REPORT OF THE INDEPENDENT PEER REVIEW PANEL
FOR THE GROUNDWATER MANAGEMENT,
MONITORING, AND MITIGATION PLAN (GMMMP)
FOR THE CADIZ VALLEY GROUNDWATER
CONSERVATION, RECOVERY AND STORAGE PROJECT
San Bernardino County, California

Prepared for:
Three Valleys Municipal Water District (TVMWD)
1021 E. Miramar Avenue
Claremont, CA 91711-2052

Prepared by:
Panel:
Anthony Brown, **aquilogic**
Mark Wildermuth, **Wildermuth Environmental**
Dave Romero, **Balleau Groundwater**
Tim Parker, **Parker Groundwater**

February 5, 2019

Figure 9: Lag in drawdown response related to the cessation of pumping at the Cadiz Project

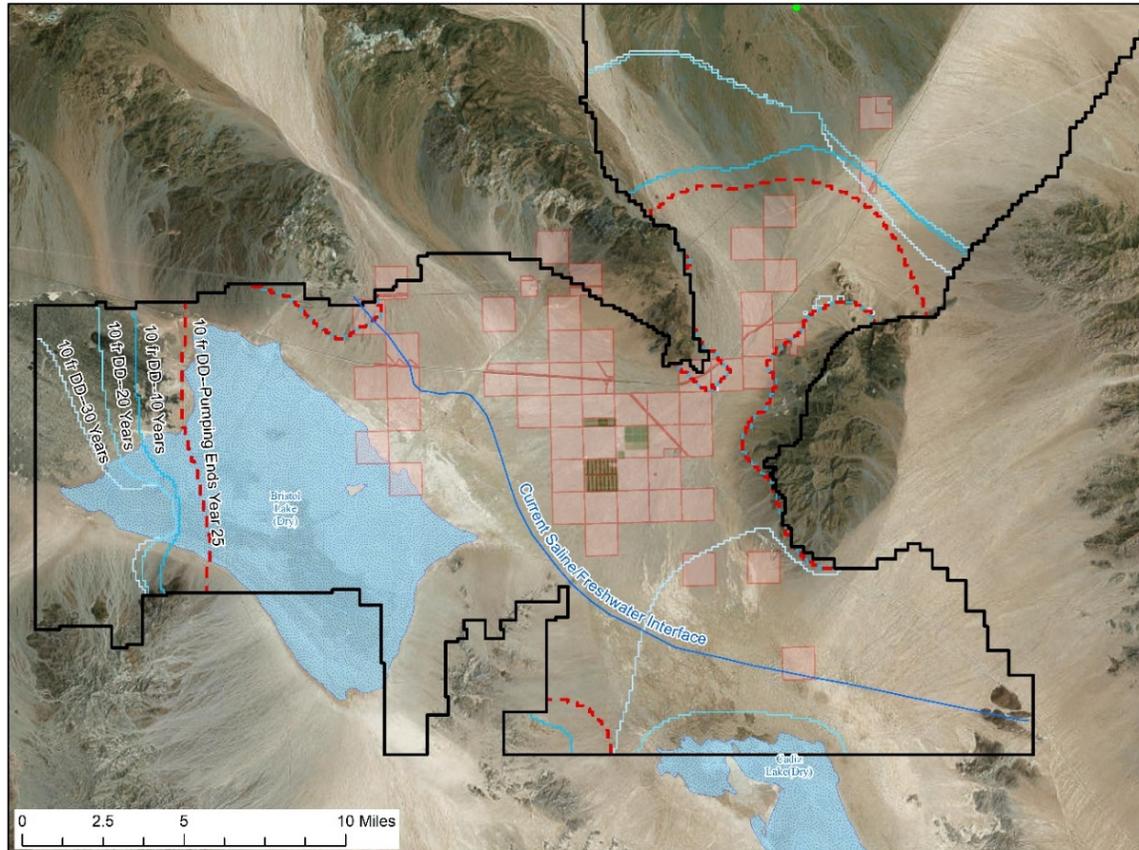
An illustration of the drawdown response in this model simulation is shown on **Figure 9**. The red dashed line (contour) indicates the location of 10 feet of drawdown after 25 years of pumping at the Cadiz Project. At the beginning of the 26th year when pumping stops, the blue lines illustrate the expansion of the 10-foot drawdown contour outward for the next 10, 20 and 30 years after pumping stops. That is, drawdown exceeds 10 feet for many years after that mitigation has been implemented – the cessation of pumping. Under such circumstances, an Undesirable Result may occur at a Critical Resource even many years after the implementation of the mitigation action (i.e., the cessation of pumping).

A groundwater level drawdown threshold (80 feet) is proposed in the GMMMP for a distance of two miles from the center of the Cadiz Project well-field. This threshold is intended to provide a management “floor” below which mitigation actions would be triggered. Such a floor was selected as it lessens the need for resource-specific mitigation actions at individual Critical Resources, as it is believed to provide a proactive Corrective Measure that would prevent significant impact.

It should be noted that the drawdown threshold two miles from the center of the Cadiz Project well-field may trigger mitigation when none is actually required. For example, if the 80-foot threshold is triggered, but unacceptable groundwater level declines are not observed closer to the springs (e.g., at monitoring well 6N15E1) or brine resources, no mitigation should be required. Conversely, if the 80-foot drawdown threshold is not triggered, but groundwater level declines observed closer to Critical Resources suggest an Undesirable Result could occur, then mitigation may be required. For these reasons, adequate monitoring is needed as close as reasonably possible to the Critical Resources. If monitoring closer to the Critical Resources indicates that an Undesirable Result could occur, then mitigation can be implemented.

Figure 10: Excerpt of Monitoring Features from Figure 5-1 of the GMMMP (ESA, 2012b)

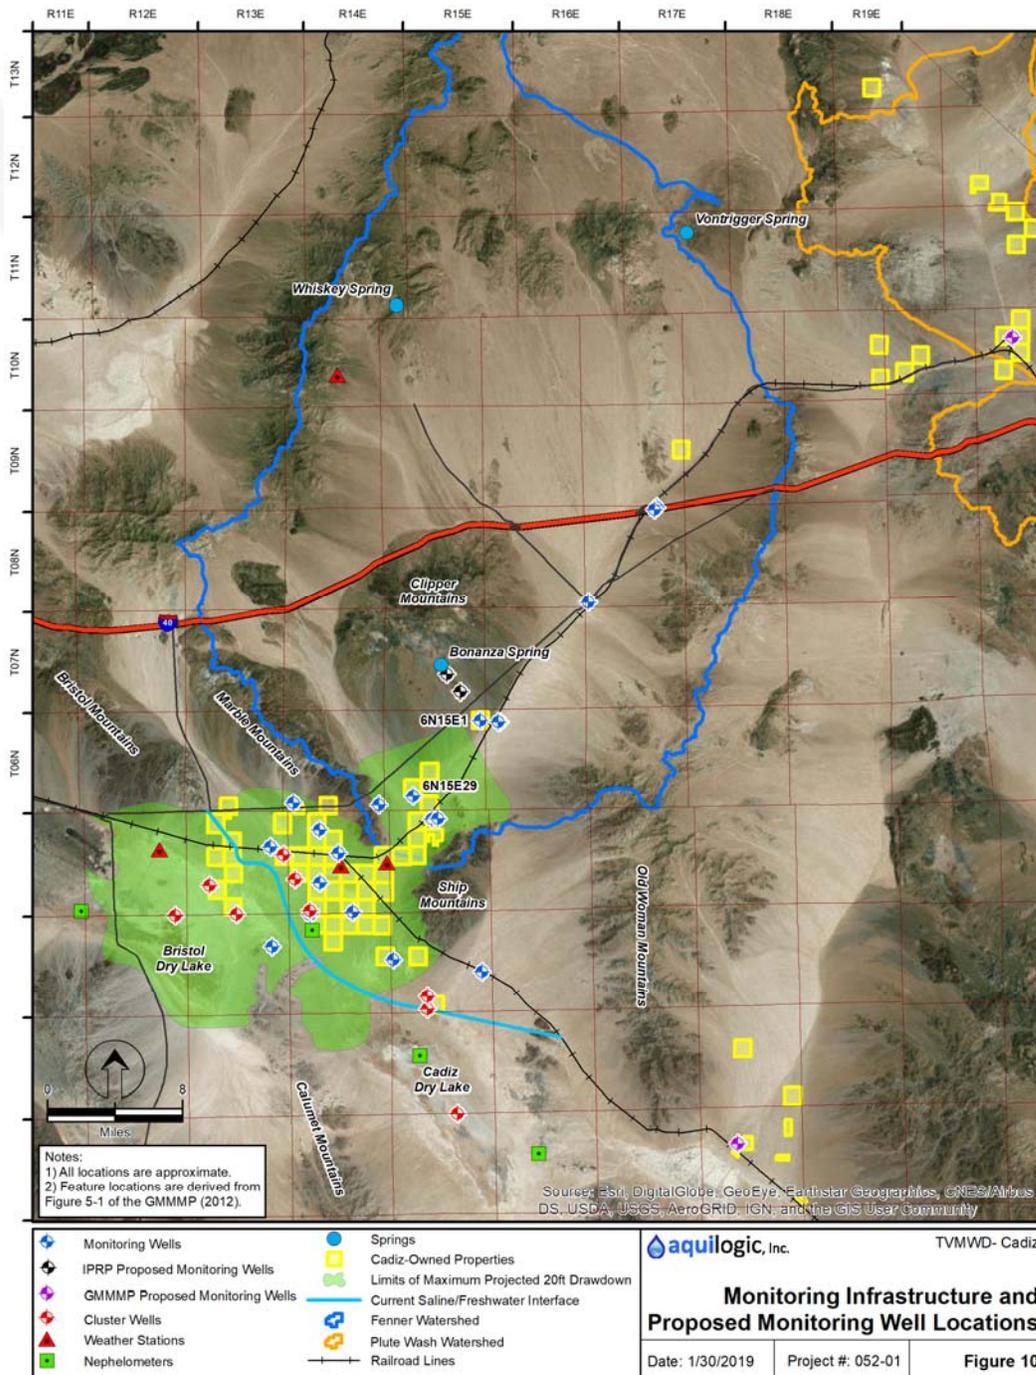
The GMMMP (ESA, 2012b) includes groundwater monitoring requirements, such as monitoring locations, monitoring type, monitoring frequency, monitoring parameters. The locations of monitoring points pertinent to Bonanza Spring and the Brine Resources are presented in **Figure 10** (an excerpt from Figure 5-1: Monitoring Features of the GMMMP [ESA, 2012b]).

The perimeter of the green area on **Figure 10** indicates the maximum extent of 20 feet of drawdown in the alluvial aquifer resulting from the proposed pumping at the Cadiz Project, with the numerical groundwater model calibrated to recharge of 32,000 AFY. The maximum extent of 20 feet of drawdown extends to the contact between the alluvium and the bedrock of the Clipper Mountains south of Bonanza Spring. It also extends beyond the mineral strip-mining operations at Bristol Dry Lake.

In the GMMMP (ESA, 2012b), it is proposed that groundwater conditions be monitored at wells 6N15E1 and 6N15E29 (see **Figure 10**) to observe the propagation of the cone of depression outward from the proposed pumping at the Cadiz Project toward Bonanza Spring. These wells would serve as sentry wells – providing an early indication of potential Undesirable Results at Bonanza Spring, assuming there is a direct hydraulic connection between the spring and the alluvial aquifer.

Monitoring well 6N15E1 is screened within the alluvial sediments of the Fenner Valley (Kenney, 2018, Figure 17 and Figure 2-7b). The well is located approximately 1.5 miles southeast of the contact between alluvial deposits (Qoaf) and the Clipper Mountains. This well will be useful in identifying the propagation of potential drawdown in the alluvial aquifer of the Fenner Valley resulting from the proposed pumping at the Cadiz Project.

Figure 11: Drawdown Beneath Bristol Lake Under Three Recharge Scenarios (GSSI, 2011)

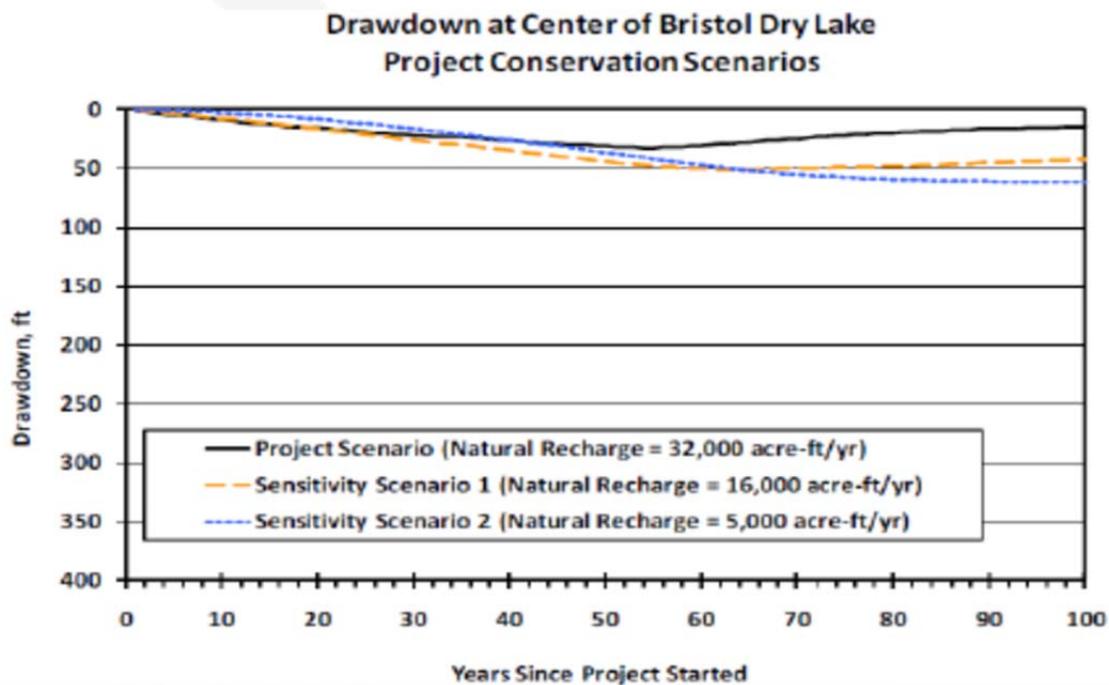
The hydrograph below in **Figure 11** (GSSI, 2011) shows the projected drawdown of groundwater levels beneath the Bristol Dry Lake during the proposed pumping at the Cadiz Project. The hydrograph was produced from numerical groundwater modeling performed by GSSI (2011). It shows that, depending on the recharge amount used in the modeling, between 30 and 65 feet of drawdown will occur beneath Bristol Dry Lake. In general, the trenches used to expose saline groundwater to evaporation and precipitate salts for mineral strip-mining operations at Bristol Dry Lake are about 12 feet deep, and the two existing strip-mining operators utilize approximately 750 AFY of brine water. Therefore, once groundwater levels beneath Bristol Dry Lake decline below 12 feet bgs, the trenches will be dry, curtailing some strip-mining operations and processes. However, it is understood that the strip-mining operations already pump groundwater from existing wells into the trenches. In addition, under natural climatic conditions, groundwater levels beneath the dry lakes decline at times, and the trenches are then dry.

Viewed strictly from the standpoint of whether the project is causing a physical change in the environment, and if there were a need for a “physical solution” if the groundwater level predictions from the modeling come to pass, it is likely that Corrective Measures will need to be implemented as outlined in the GMMMP (ESA, 2012b) to mitigate impacts on the strip-mining businesses. These Corrective Measures include operational modifications and/or negotiation of a compensation or mitigation agreement with mineral strip-mining operator(s). Such an agreement would require that Cadiz bear all of the costs of drilling wells to pump the brine, as the strip-mining operators do presently in some locations, rather than rely on the high groundwater table to fill evaporation/precipitation trenches. For example, brine extraction wells deeper than 70 feet bgs could be installed to maintain mineral strip-mining at Bristol Dry Lake.

Figure 12: Simulated Et for Three Recharge Scenarios (lower chart is an expansion of the bottom 1,500 AFY of the upper chart).

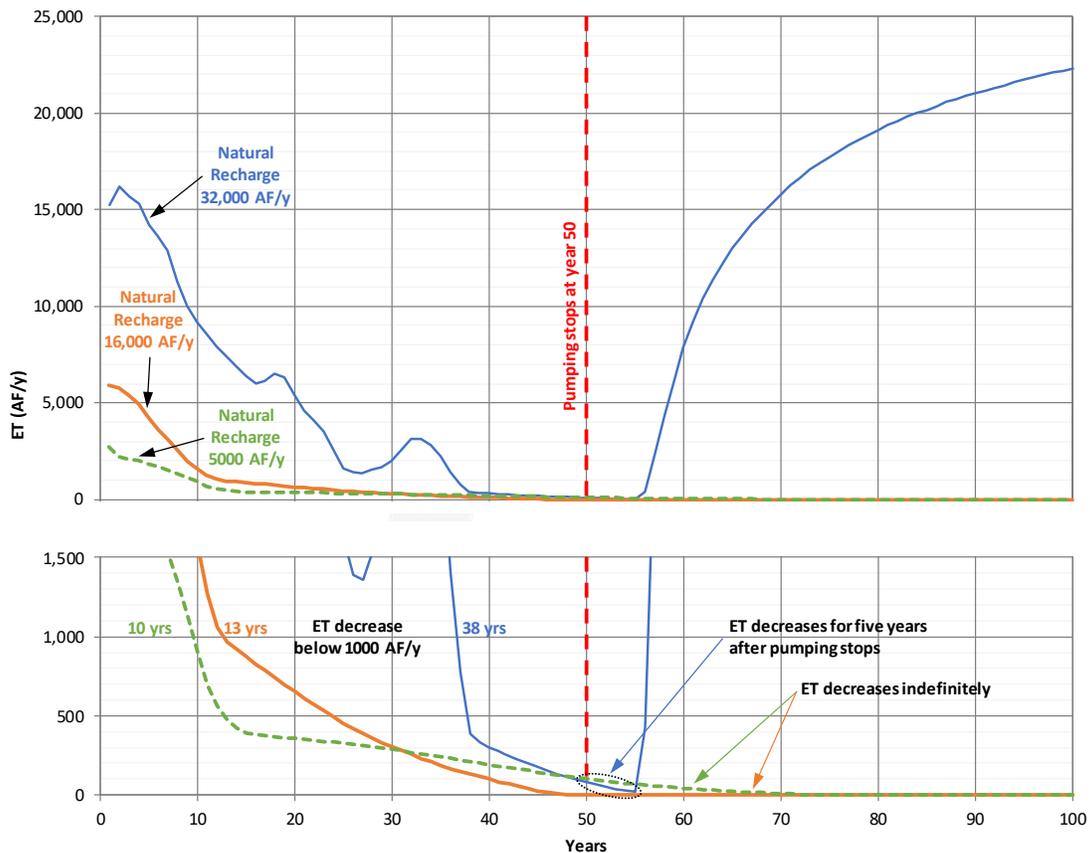
GSSI (2011, Tables 2, 3 and 4) ran three model simulations to provide water budget tables that include total Et for three project scenarios with different recharge rates (Project scenario: 32,000 AFY, Sensitivity 1: 16,000 AFY and Sensitivity 2: 5,000 AFY - GMMMP, p. 41 - 42). **Figure**

Two important observations are apparent in **Figure 12**:

Figure 13: Potential Geophysical Survey Areas

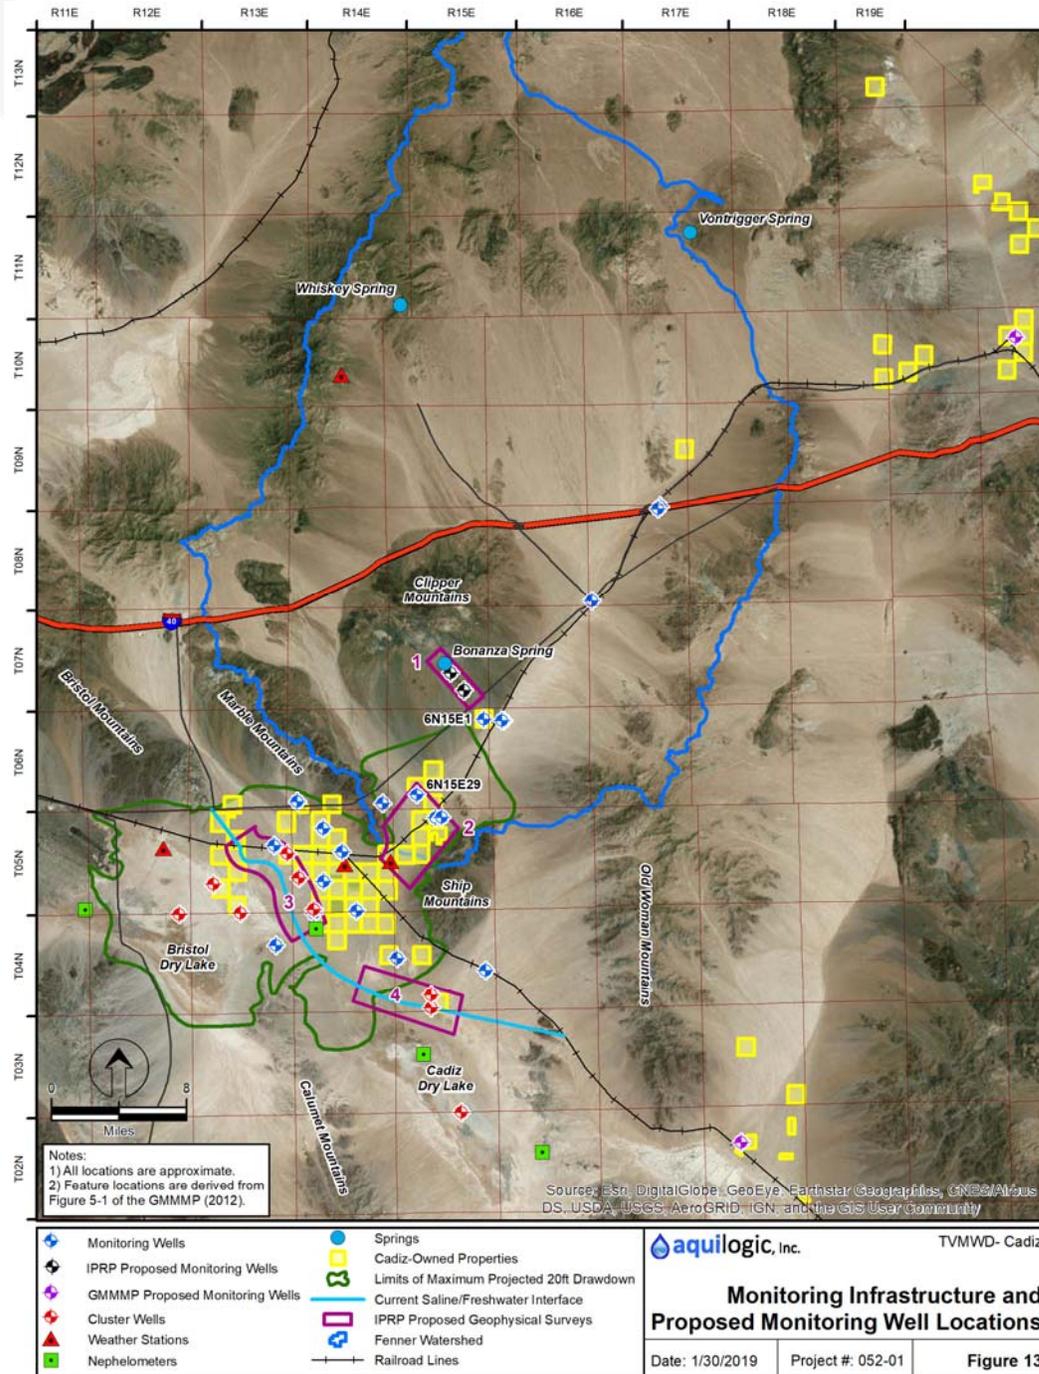
It is recommended that, within one year of the commencement of the proposed pumping at the Cadiz Project, geophysical surveys be completed in two areas to assist in assessing geologic conditions (areas 1 and 2 on **Figure 13**):

To provide additional information on hydrogeologic conditions between Bonanza Spring and the alluvial aquifer in the Fenner Valley below, it is recommended that the following additional monitoring wells be installed (see **Figure 13**):

Given the above, it is recommended that the location of the interface be mapped spatially and at depth using geophysical techniques (areas 3 and 4 on **Figure 13**) prior to the commencement of pumping at the Cadiz Project. Given the relative homogeneity of the alluvial deposits and known groundwater depth, EM techniques will be effective at mapping the mineralization of groundwater (i.e., TDS content). Different EM tools can be used to spatially map groundwater mineralization at various depths. ERT can also be used to map vertical profiles of groundwater mineralization along cross-section lines. The outputs from the spatial EM mapping and ERT can be combined to create a three-dimensional visualization of the saline-fresh water interface. The results of this geophysical mapping can be used to locate the proposed cluster wells, and select the screened depths at each cluster. It is further recommended that the geophysical mapping be repeated every five years after the proposed pumping at the Cadiz Project is initiated. This will allow the migration of the saline-fresh water interface to be mapped in three-dimensions over time. An understanding of the migration of the saline-fresh water interface will allow any potential mitigation actions to be optimized (e.g., recharge of fresh water in areas and depths of preferential migration).
